CONTRACT CHANGE ORDER NO. 17451
SHEET 3 OF 9

MARK	DATE	DESCRIPTIONS	BY	CH'D	CCO#
0	02/08/13	ADDITIONAL MISCELLANEOUS ELEVATOR DETAILS	JB	AE	17451

SAN FRANCISCO OAKLAND BAY BRIDGE
EAST SPAN SEISMIC SAFETY PROJECT
SELF-ANCHORED SUSPENSION BRIDGE
(SUPERSTRUCTURE & TOWER)

TOWER ELEVATOR ENCLOSURE DETAILS NO.2

ELEVATOR DETAIL NO. 3

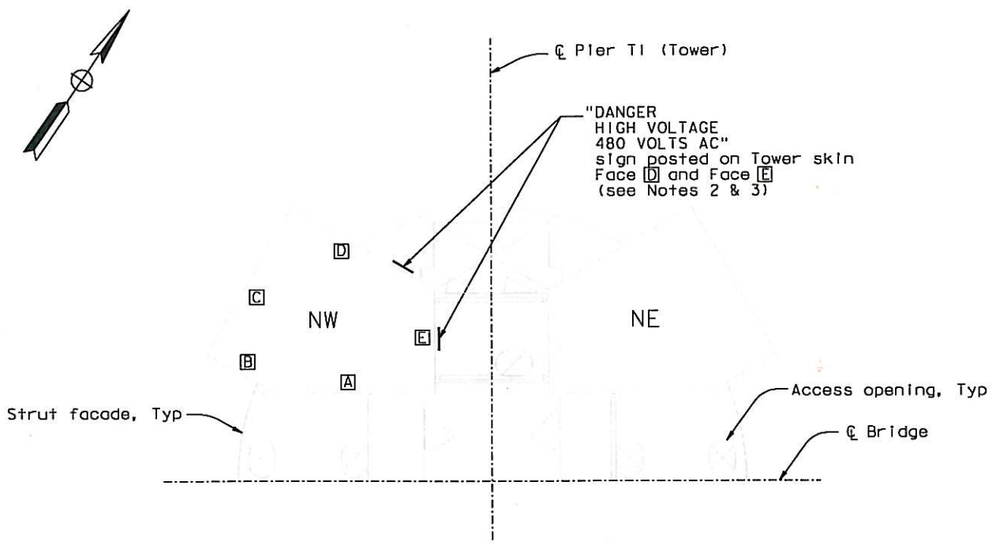
Durable signs shall be placed at eye level (1.5 m) above the top of landing/platforms located at the following elevations:

1. Signs shall be sized 356 wide by 254 high minimum, with lettering not less than one-inch high on a contrasting background.
2. For list of landings/platforms at which signs shall be placed, see Table 1. Additional signs shall be placed as directed by the Engineer.
3. All signs shall be drilled and tapped into the outside faces of the tower skins or parapet walls, except for tower elevator enclosure at Elev 161.500 m where the signs shall be attached to the inside faces the wire mesh.

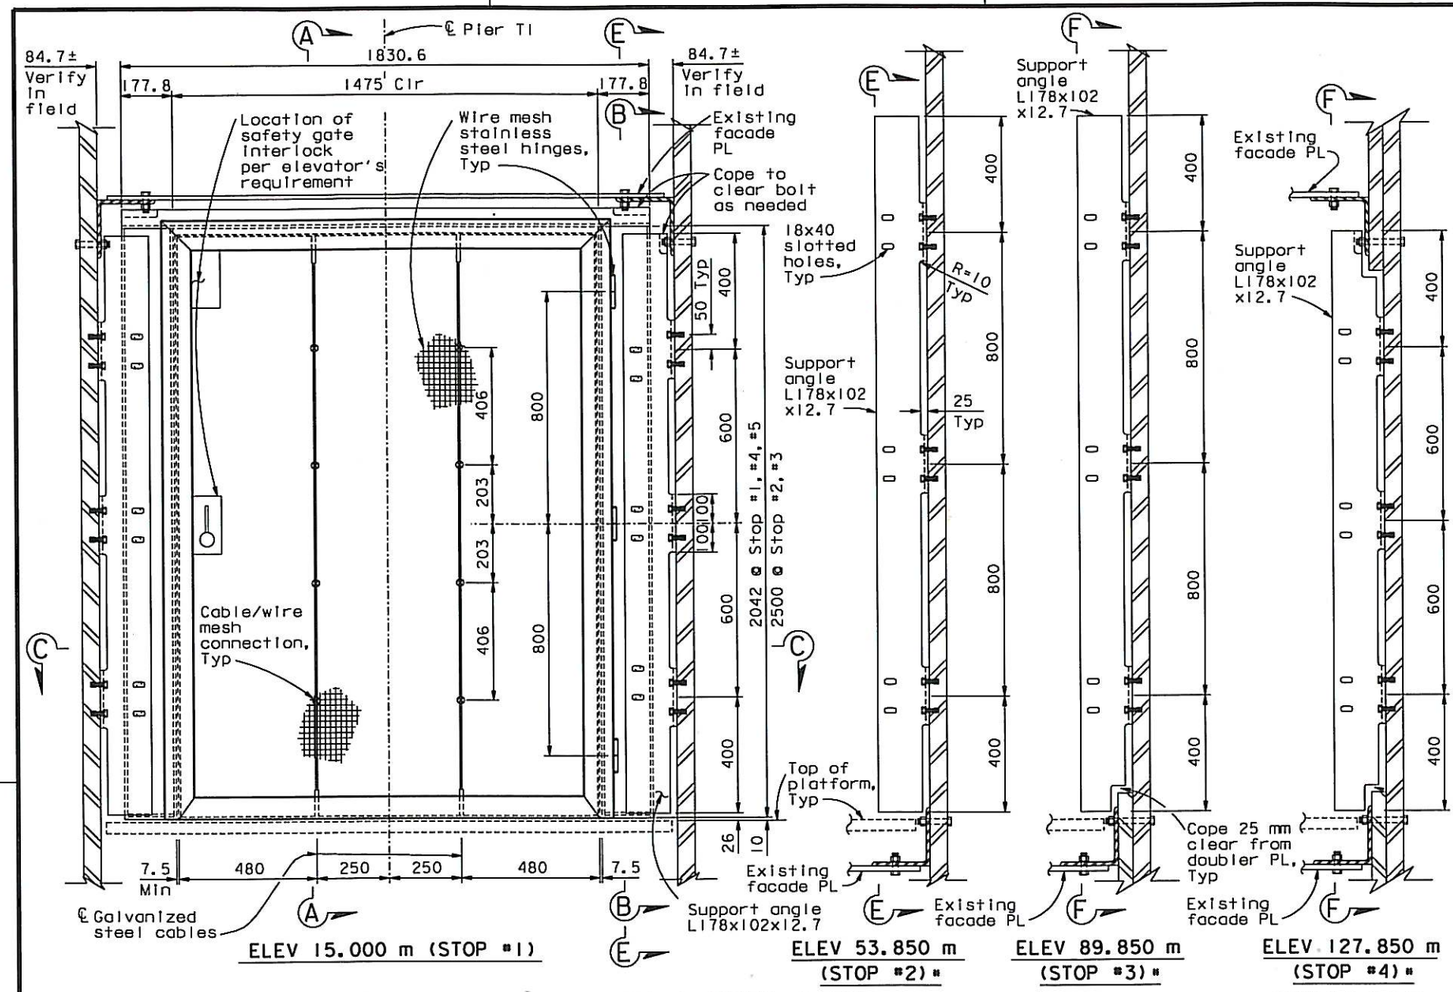
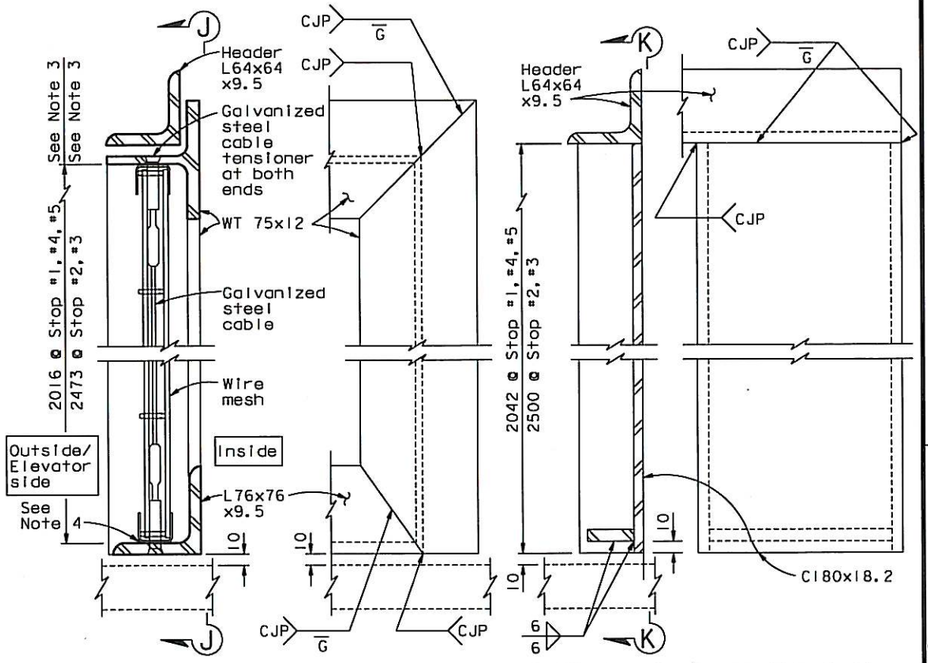
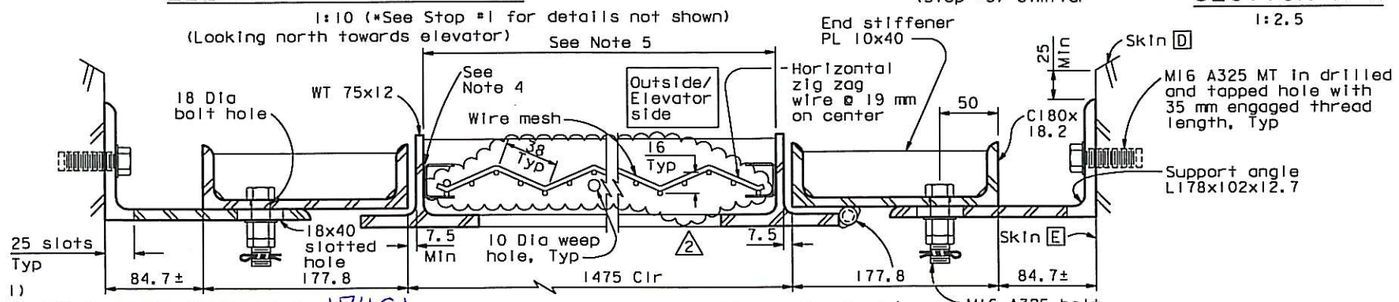
1. Provide 5 mm camber to account for self weight deflection of safety gate.
2. For Section E-E & F-F, see "Tower Elevator Enclosure Detail No.4" sheet.
3. Vertical height of steel frames shall be adjusted to receive the horizontal zigzag wires with U-band frame at top and bottom.
4. Welding of wire mesh U-band frame to steel frame shall be in accordance with wire mesh manufacturer' recommendations.
5. Width of steel frames shall be adjusted to receive the wire mesh with U-band frame.

TOWER ELEVATOR ENCLOSURE DETAILS NO. 3

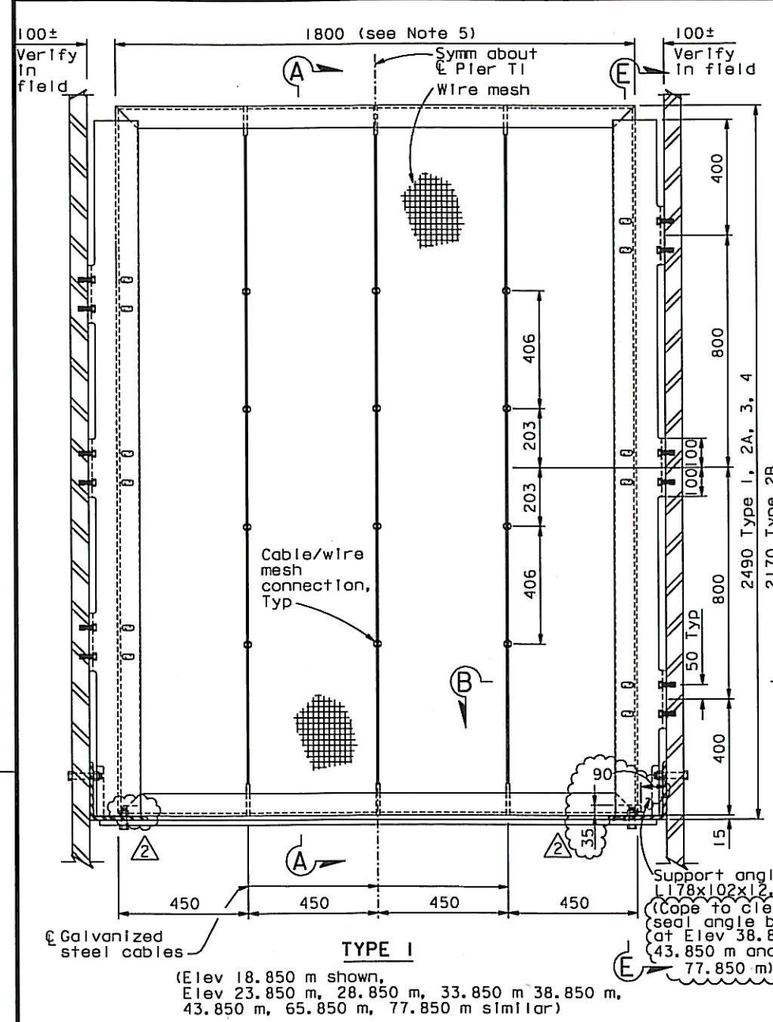
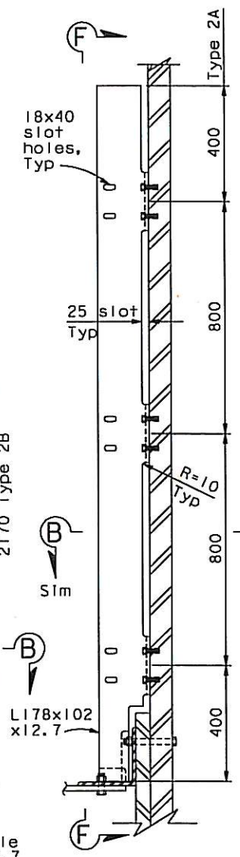
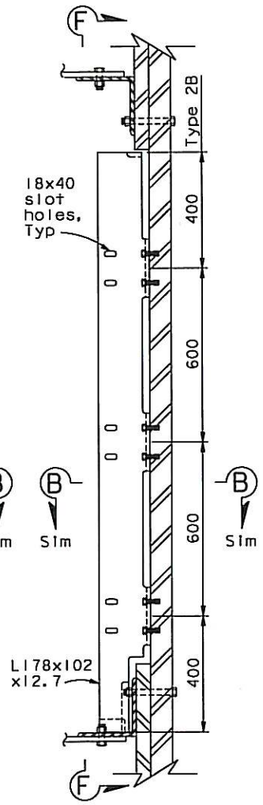
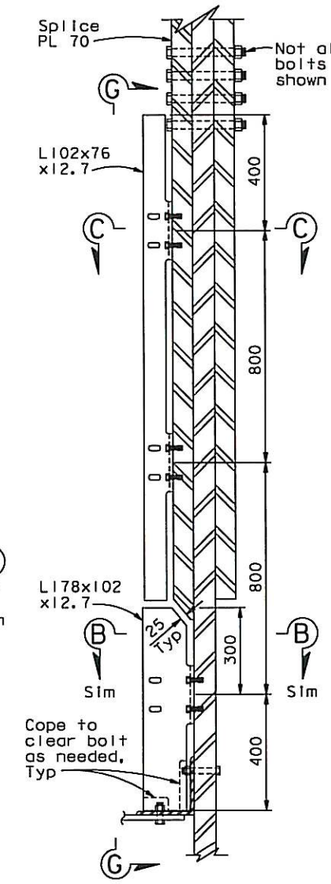
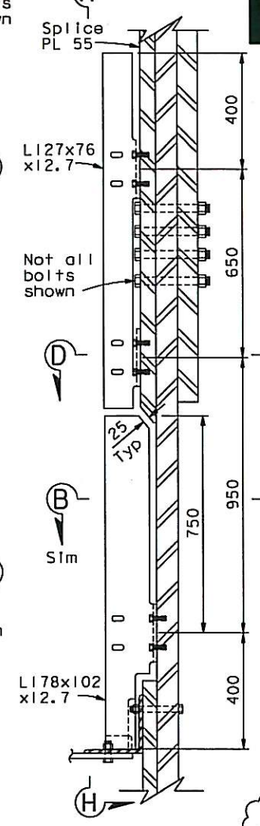
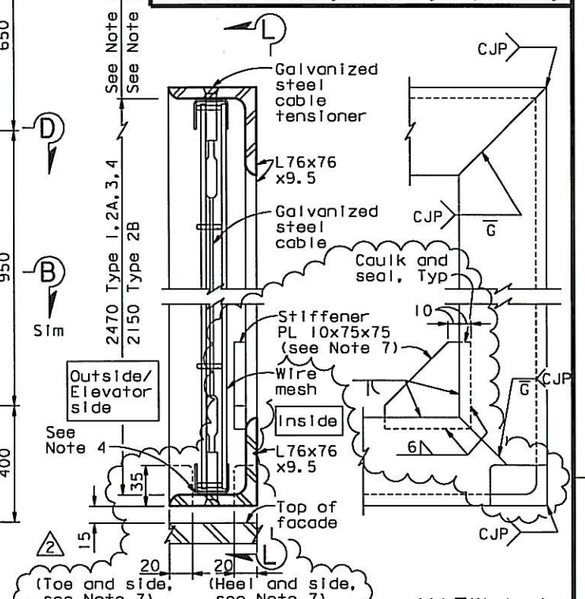
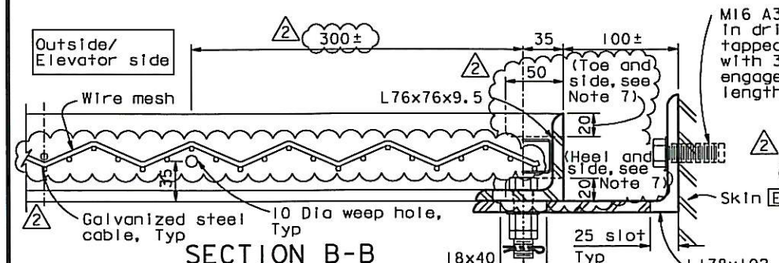
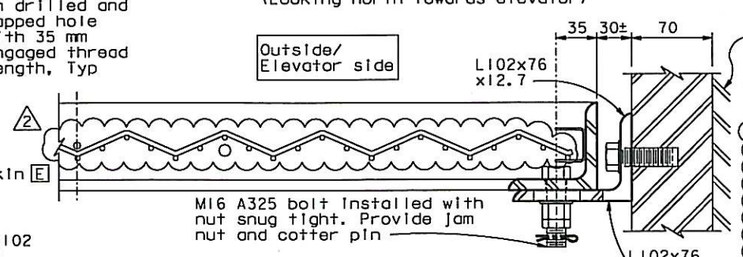
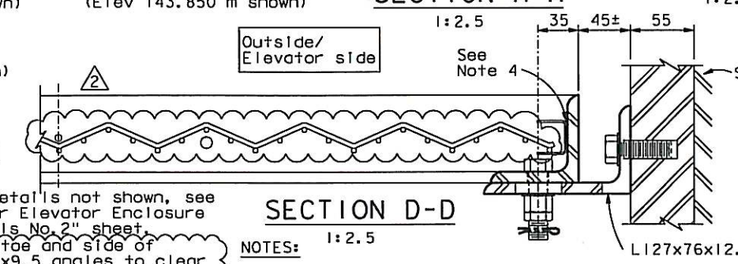
6. For details not shown, see "Tower Elevator Enclosure Details No. 2" sheet.
7. Cope toe and side of 76x76x9.5 angles to clear seal angle bolts at Elev 33.850 m, 38.850 m, 43.850 m, 65.850 m and 77.850 m. Cope heel and side of 76x76x9.5 angles to clear seal angle bolts at Elev 38.850 m, 43.850 m and 77.850 m. Stiffener PL shall be added at coped locations. Field verify all dimensions prior to fabrication.

1. For Sections E-E, F-F, G-G, H-H, see "Tower Elevator Enclosure Details No. 4" sheet.
2. Attachment of wire mesh to steel frames shall be per wire mesh manufacturer's requirements.
3. Vertical clear height of steel frames shall be adjusted to receive the wire mesh U-band frame.
4. Welding of wire mesh U-band frame to steel frame shall be in accordance with wire mesh manufacturer's recommendations.
5. Width of steel frames shall be adjusted to receive the wire mesh with U-band frame.

TOWER ELEVATOR ENCLOSURE DETAILS NO. 4

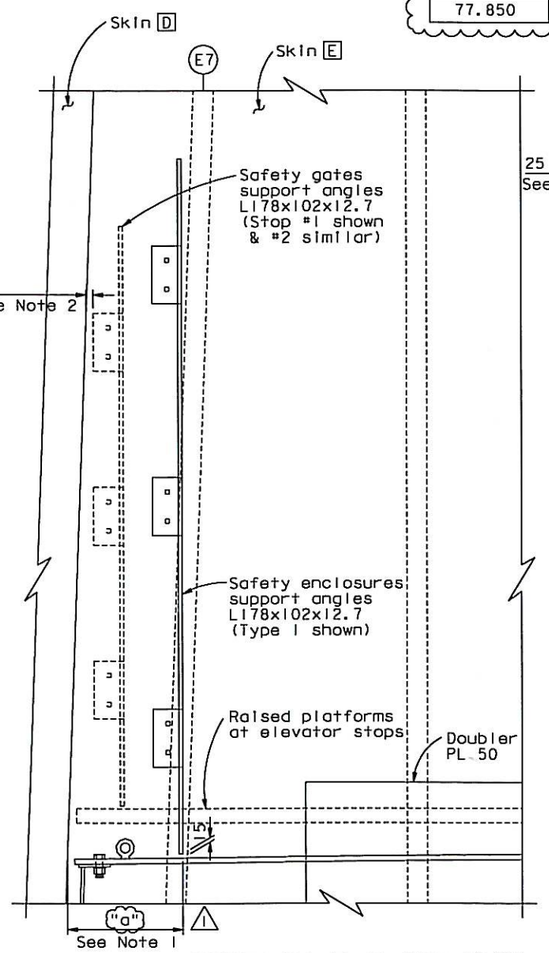
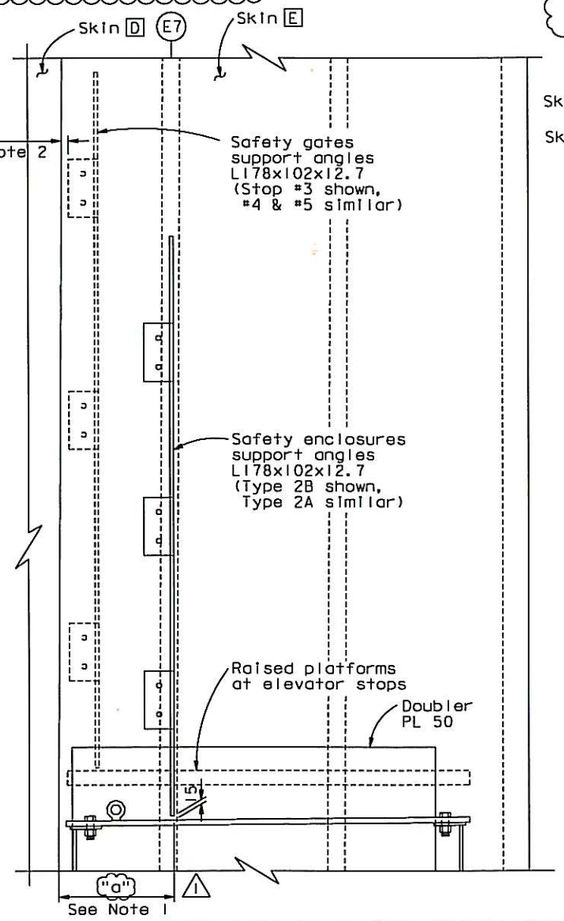
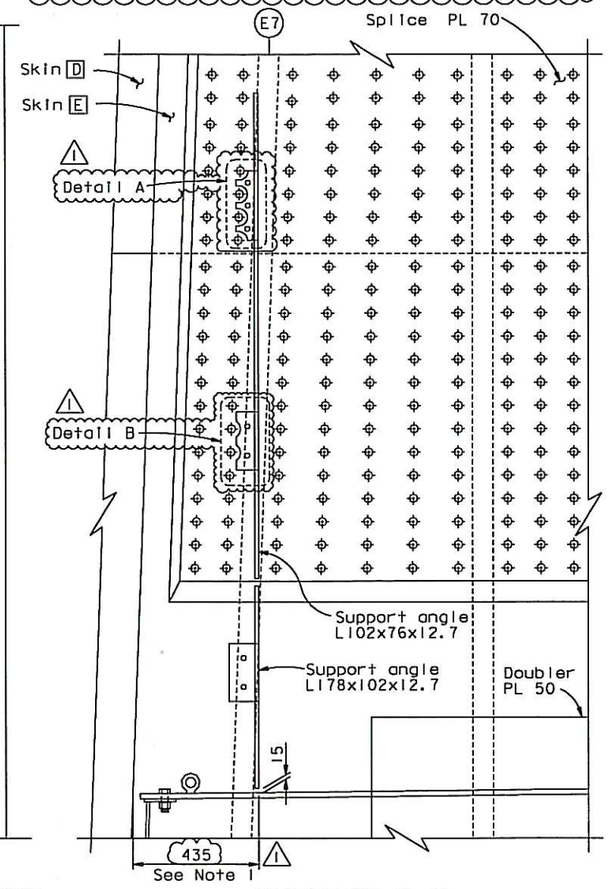
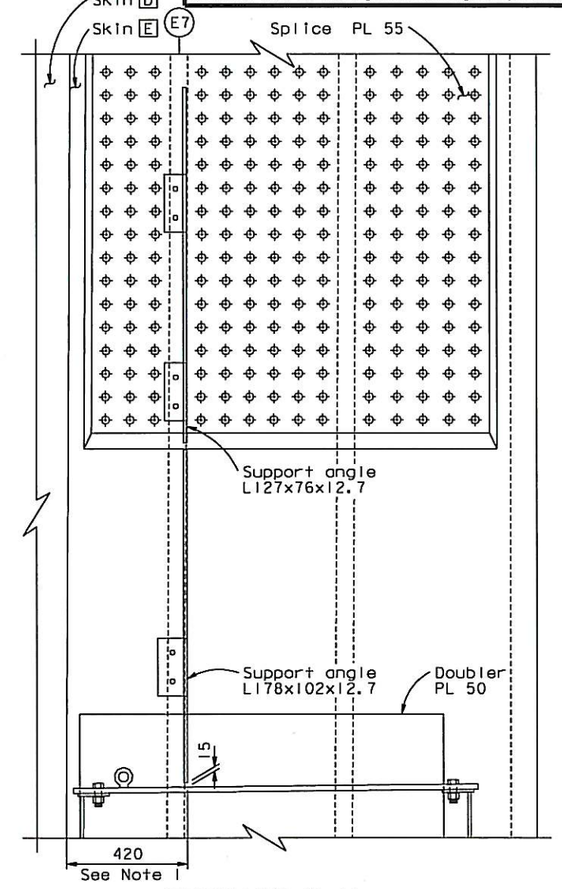
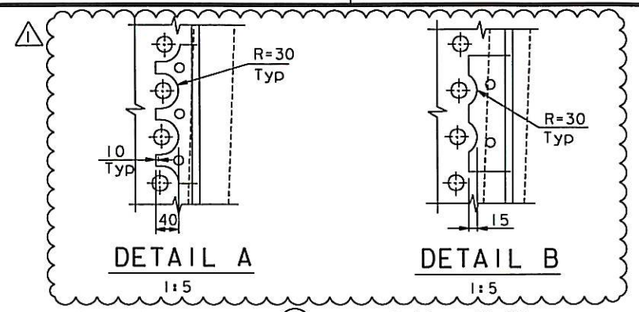
1. Dimension may be adjusted to clear splice bolts, pad eyes and other interferences.
2. Dimension may be increased so that safety gate interlock will not interfere with the elevator.

TOWER ELEVATOR ENCLOSURE DETAILS NO. 5

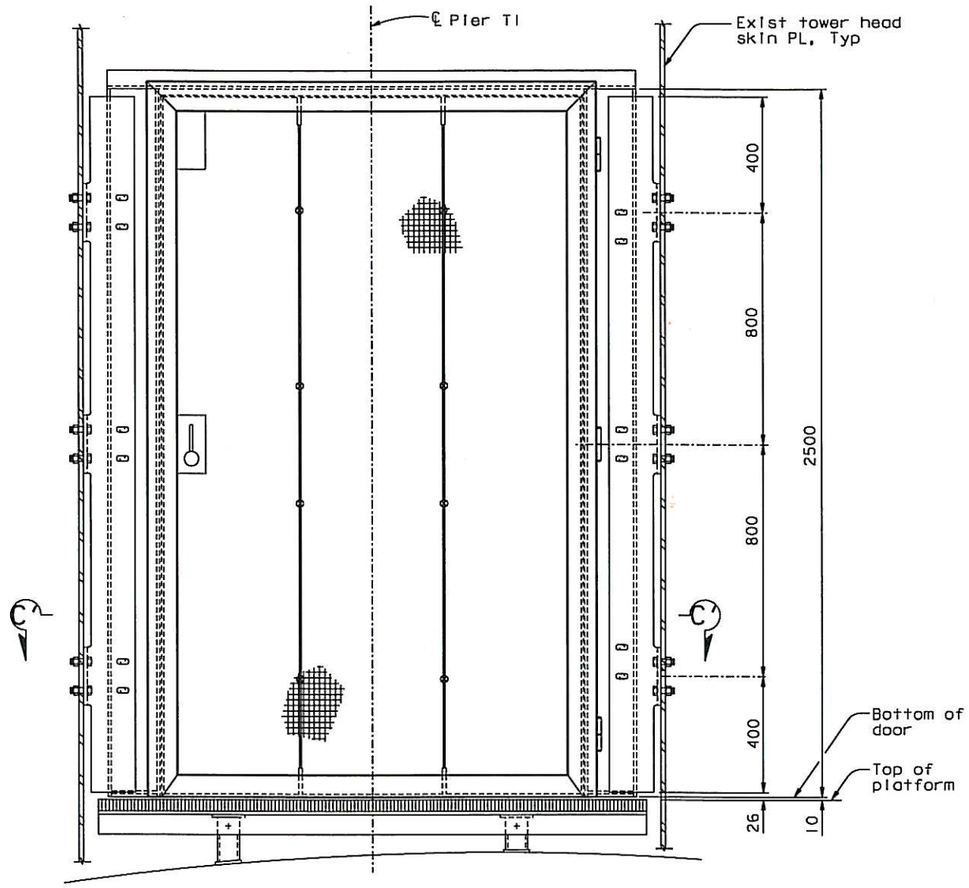
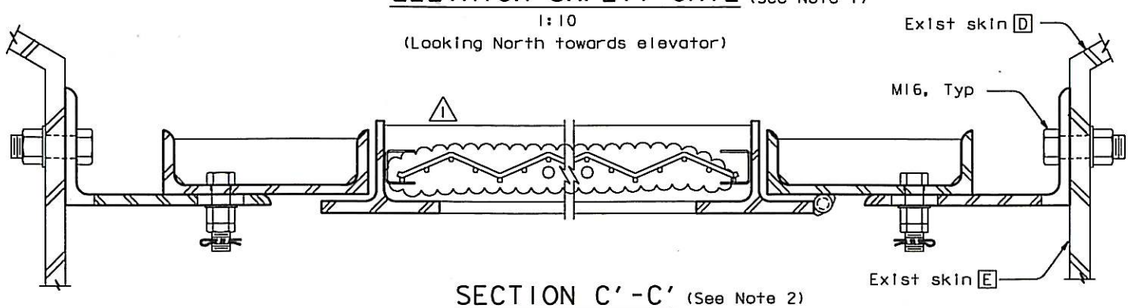
1. Stop #6 is similar to Stop #3. For details not shown, see "Tower Elevator Enclosure Details No. 2" sheet.
2. For Details not shown, see Section C-C on "Tower Elevator Enclosure Details No. 2" sheet.
